Appeal of Board of Zoning Appeals Decisions Related to

United Village

Restaurant Pavilions

**Zoning File: #24-033509 (Appeal of Zoning file #24-023545)
1566 University Ave W (Temporary Address)**

EAST ELEVATION - SIMPSON STREET

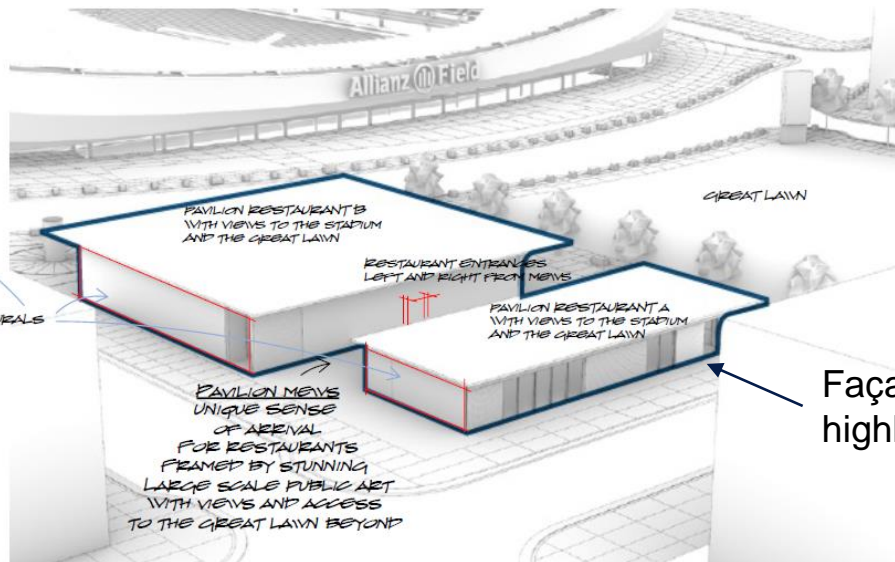
Facade in question highlighted.

Variance #1 – Above Grade Openings (North Façade, North Bldg)

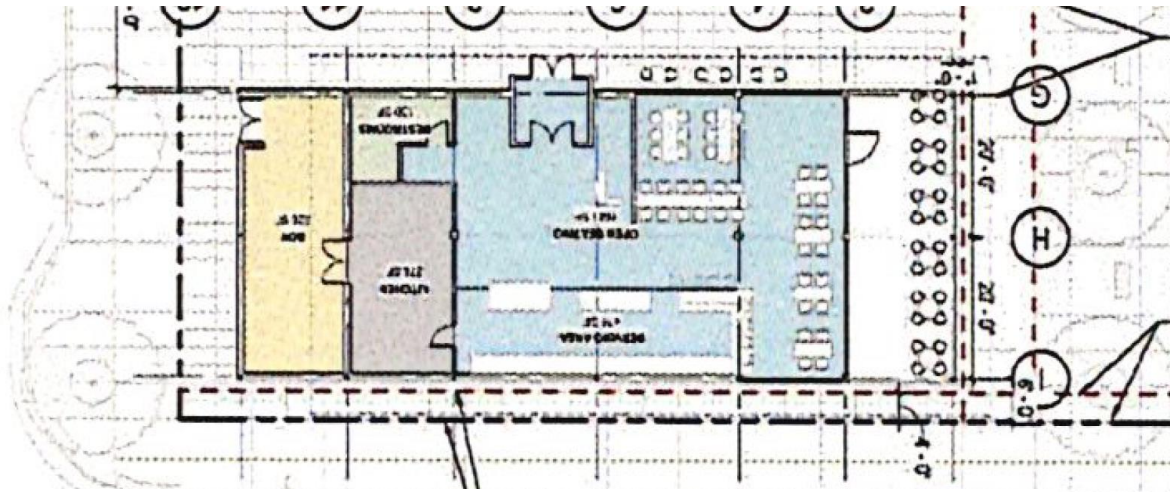
- City Council Resolution 23-1442 - 30 percent of the area along the ground floor along street facing facades required.

Northern Building

- Northern Façade: 19.6%, 10.4% variance

F1 A - North Elevation

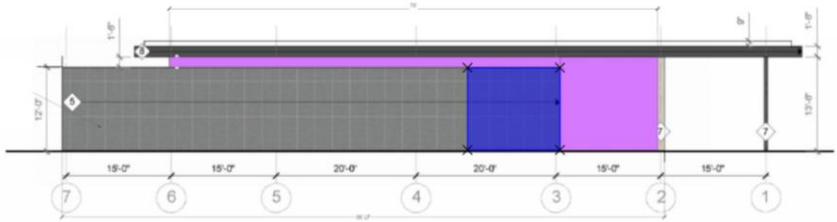
- METHODS
1. 19.6%
 2. 19.6%
 3. 71%

Dark blue box is about 153 square feet. (Size of shortage.)

Variance #2: Primary Pedestrian Entrance

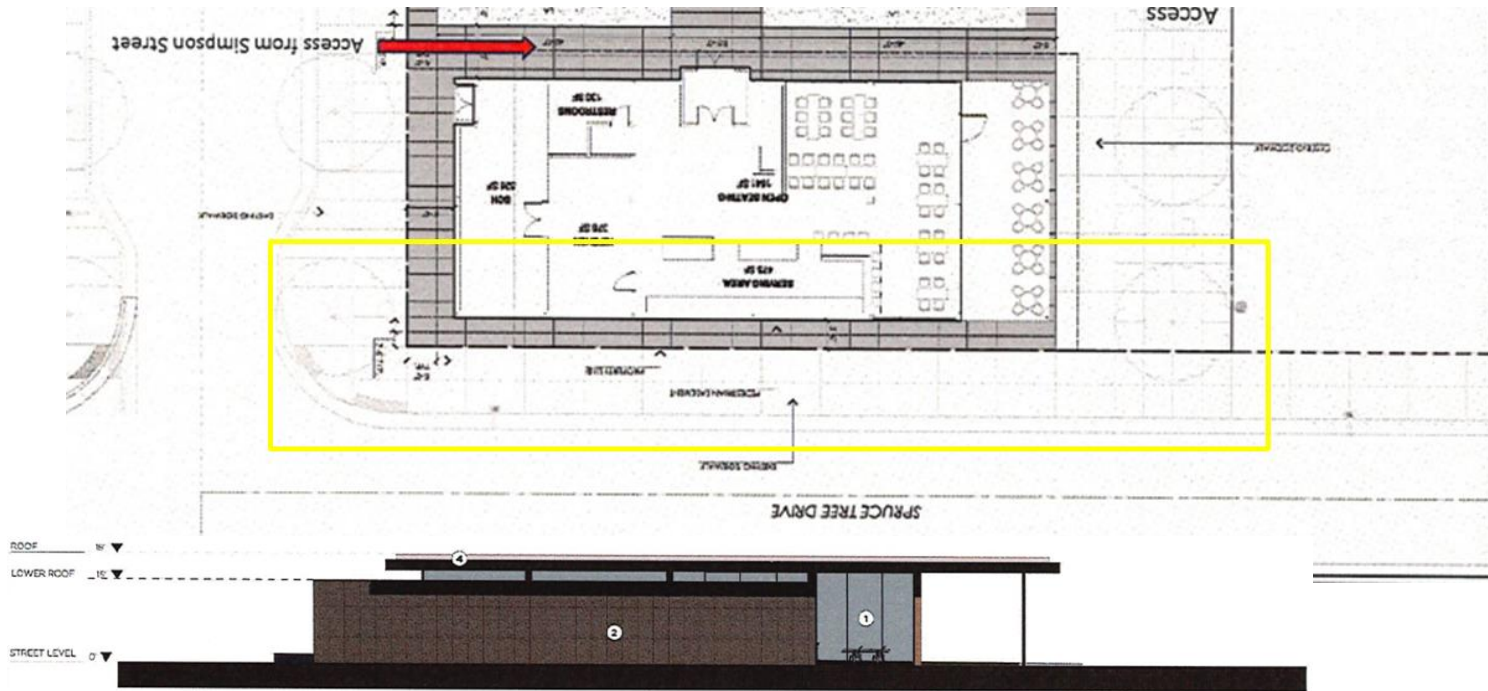
3. All new buildings within the master plan boundary must have a primary pedestrian building entrance on arterial, collector, and/or local streets.

View from Spruce Tree

F1 A - North Elevation

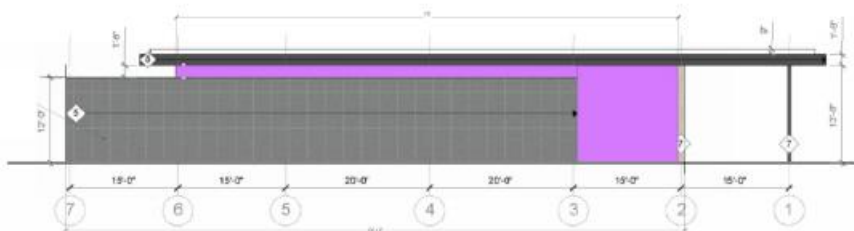
North Building North Facade

NORTH	
	SF

Base Façade 1462

Base Glazed 286

proportion glazed 19.6%

439 Required
153 Shortfall
